Questions/Answers to EN 81-20:2014 & EN 81-50:2014

New Answers are highlighted in yellow

Figure 19 — Examples of arrangements of rope retainers

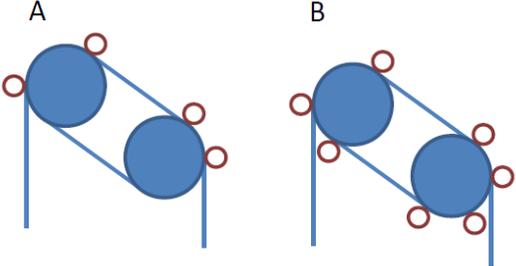
What about rope retainers in double wrap systems?

Single wrap is clear:

What is correct for Double wrap, A or B?

The text of EN81-20 was written based on single wrap solutions.

In the case of double wrap the "A" diagram should be sufficient to meet the requirement of the rope entering and exiting the sheave arrangement.

This is consistent with other worldwide standards on lift design.

The text should be amended to state this is based on single wrap, or that for double wrap the solution applies to the sheave/pulley set.

Figure O.1 - Machinery spaces - Access (6.1)

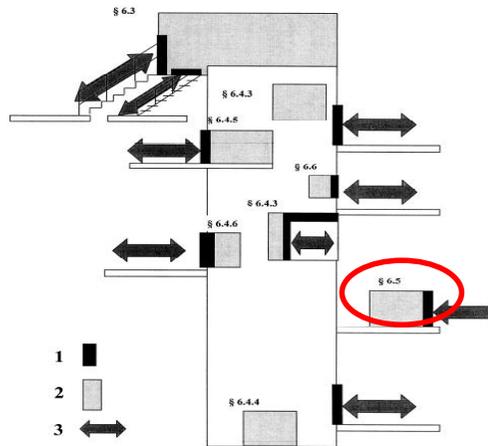
If it doesn't matter to install over regular distance away, I want to know how long distance normally installing them.

(ex. Within 100m, under two floors, no regulation, etc)

Also, I want to know if there is additional requirement when installing control cabinet over regular distance away.

Here I want to know the definition of **Machinery cabinet** from Article 6.5.2.

Additionally, I want to know the definition of **Machinery**

outside of the well. The additional disconnection and isolation devices inside the well shall be in accordance with EN 60204-1:2006, 5.5.

There is no requirement in the standard to give a maximum distance of the main switch from the machinery in the well.
